Service Update

53530 Tail Lamp Condensation

Reference Number: N162053530

Release Date: February 2017
Revision: 00

4578944

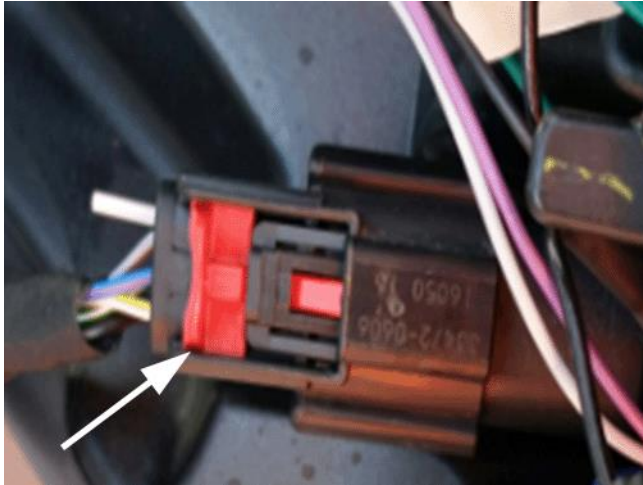
2. Remove the rubber grommets and discard.
3. Clean any lubricant from the body and paint by using soap and water.
